Safety Defect and Noncompliance Report Guide for Vehicles  
**Amended PART 573 Defect and Noncompliance Report**

**On November 6, 2006, Motor Coach Industries, Inc. decided that a defect which relates to motor vehicle safety exists in the motor vehicles listed below, and is furnishing notification to the National Highway Traffic Safety Administration in accordance with 49 CFR Part 573 Defect and Noncompliance Reports.**

# Service Bulletin No. 277C

# Service Bulletin No. 320

Figure 1.

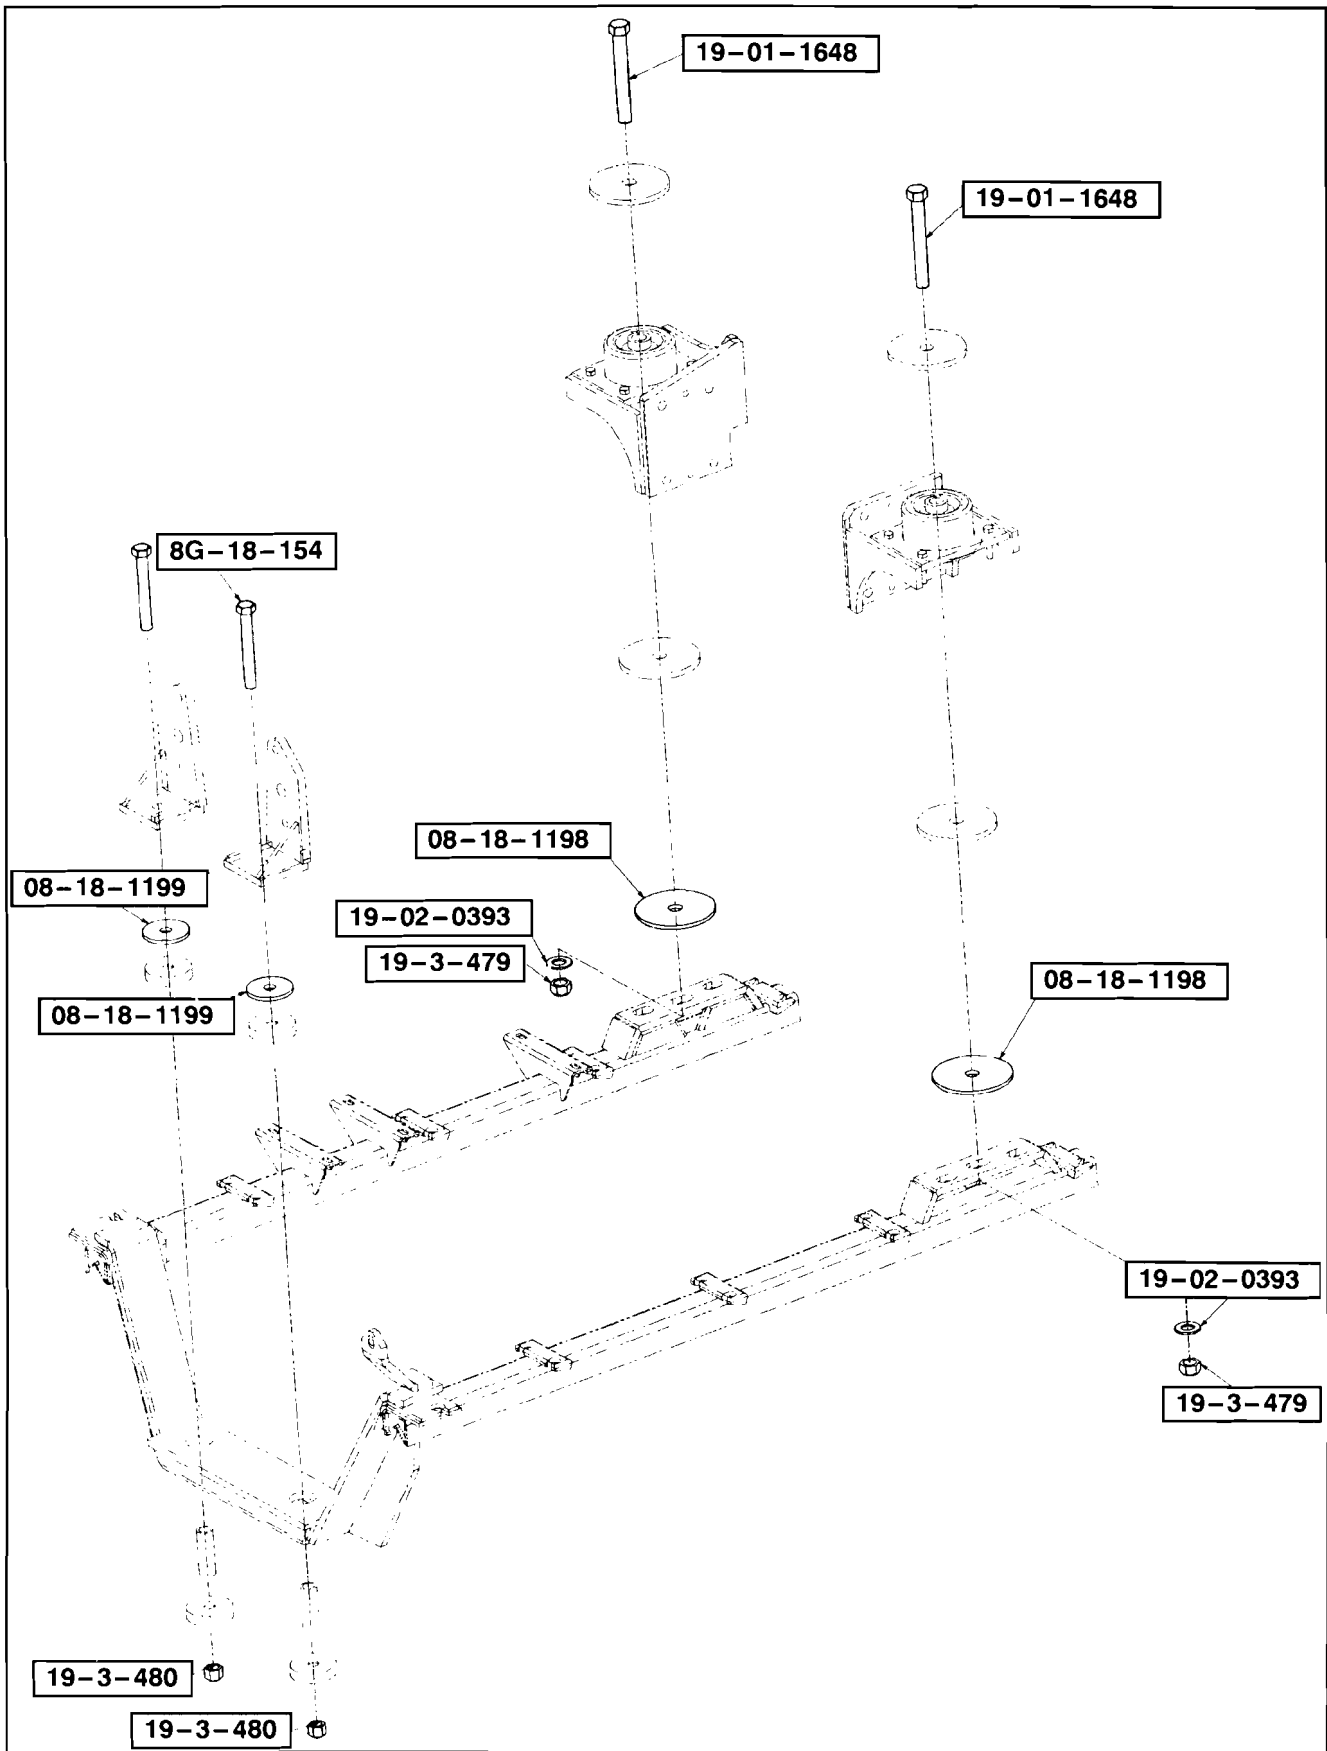
1. Turn the main battery disconnect switch to the " OFF " position. Chock both sides of the tires.
2. Open the engine compartment doors. Locate the engine remote and position the ENGINE RUN and ENGINE START to the OFF position.
3. Locate the engine cradle mounting hardware shown in Figure 1 ( four locations ).
4. Remove and discard the existing locknuts only from the four locations shown in Figure 1.

7. Remove and discard the existing fastener ( and washer if applicable ). Install appropriate shim ( p/n 08-18-1198 or 08-18-1199 ) and new mounting hardware provided in Parts list. Tighten nut hand tight only.
8. Repeat Step 7. to next fastener.

9. Upon completion of installing the four shims and mounting hardware, lower the jack removing all stress from the engine. Remove the jack from under the coach.
10. Torque 19-3-480 to 285–385 lbs.-ft. Torque 19-3-479 to 451–546 lbs.-ft.

Figure 3. Reference photo.

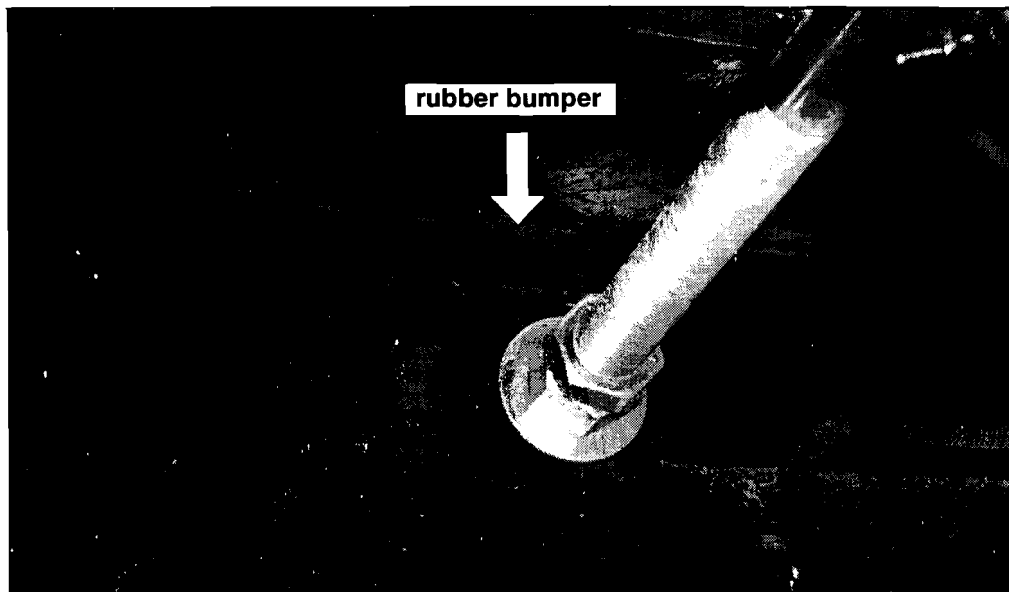
11. Locate the four existing rubber bumpers on the tag axle suspension assembly ( Figures 3 and 5 ).

12. Remove existing bumper assembly and discard. DO NOT re-use existing bumper.

13. Disk sand the mounting surface in preparation of good reassembly.
14. Install the new rubber bumper ( p/n 12G-1-5 ) and bumper block spacer ( p/n 12G-1-6 ) ( Detail B / Figure 5 ).

**Figure 4. Reference photo.**

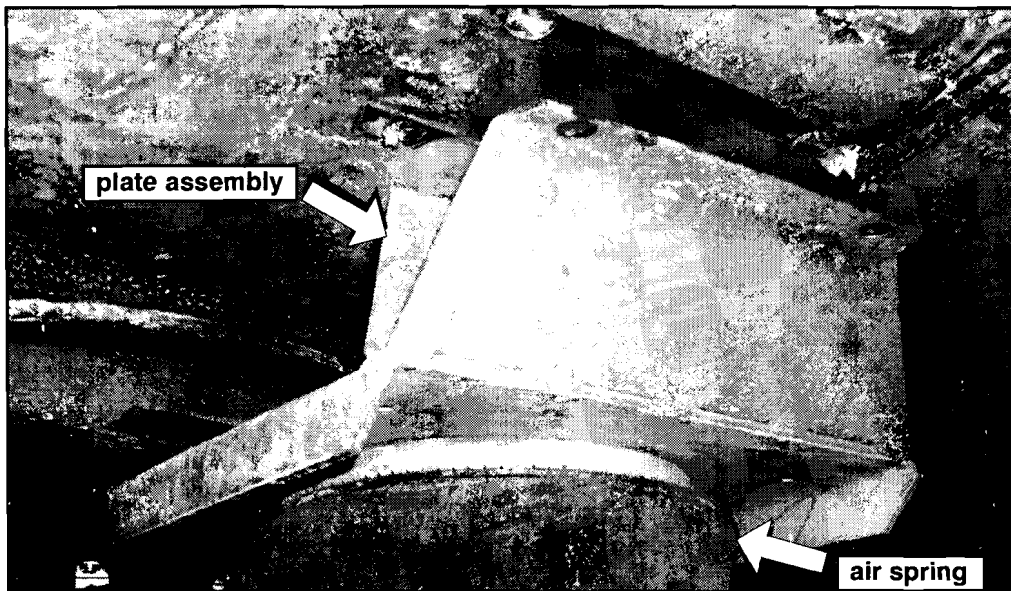
15. Remove and discard the plate assembly and mounting hardware ( Figures 4 and 5 ).

16. Install the new plate assembly ( p/n 12-04-1160 ) and spacer ( p/n 12-04-1083 ) in the locations shown in Figure 5., using the new plate assembly mounting hardware provided in the Parts list. Torque nut ( p/n 19-3-314 ) to 18–22 ft.-lbs.
17. Align and position the spacer ( p/n 12-04-1074 ) in the location shown in Figure 5.

Figure 2.

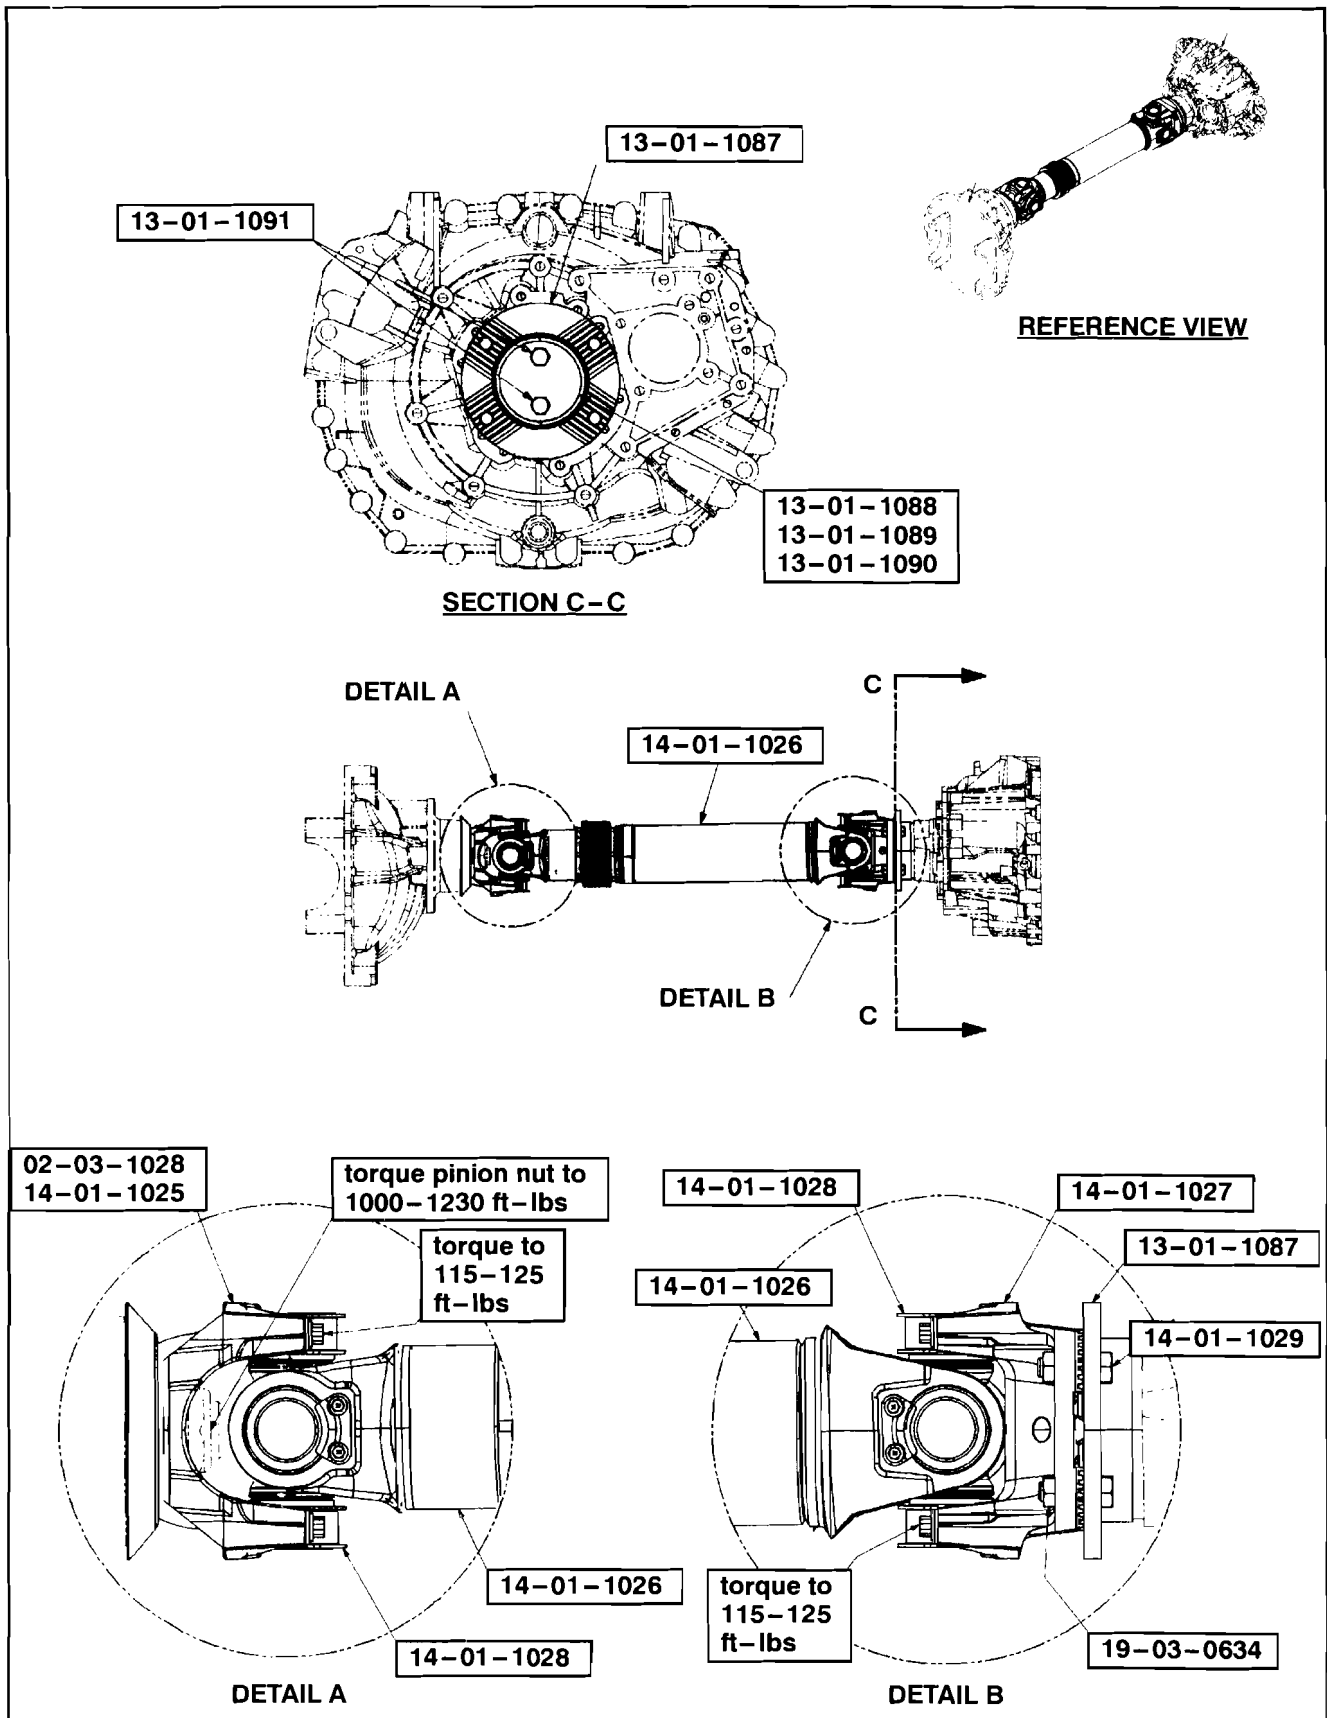
11. Using tool no. 20-710, install the drive axle pinion seal ( p/n 02-03-1028 ) ( refer to Figure 2 ).
12. Lubricate the seal mounting surface of the end yoke assembly ( p/n 14-01-1025 ) and install on the output shaft taking care not to damage the seal. Install the washer and pinion nut removed in Step 10. and torque the pinion nut to 1000-1230 lb-ft.

14. Lubricate the seal contact surface on the output flange ( p/n 13-01-1087 ) and install in transmission using plate ( p/n 13-01-1091 ) , o-ring ( p/n 13-01-1089 ) and bolts ( p/n 13-01-1091 ). Apply Loctite to bolts and torque to 80-95 lb-ft.

15. Using bolts ( p/n 14-01-1029 ) and nuts ( p/n 19-03-0634 ), install flange yoke ( p/n 14-01-1027 ) to output flange. Torque to 115-125 ft-lbs.

16. Using the straps and bolts kit ( p/n 14-01-1028 ), install the driveshaft ( p/n 14-01-1026 ) being sure to install the slip yoke end towards the drive axle. Torque the bearing cap bolts to 115 - 125 lb-ft.
17. Re-fill the drive axle with oil saved in Step 2. Top-up level as required.
18. Re-fill the transmission with fluid saved in Step 2. Top-up level as required.
19. Using grease ( p/n 21-7512-5 ), grease driveshaft u-joint.
20. Reinstall the driveshaft guard and fasteners removed in Step 2. Torque fasteners to 16-28 lb-ft.
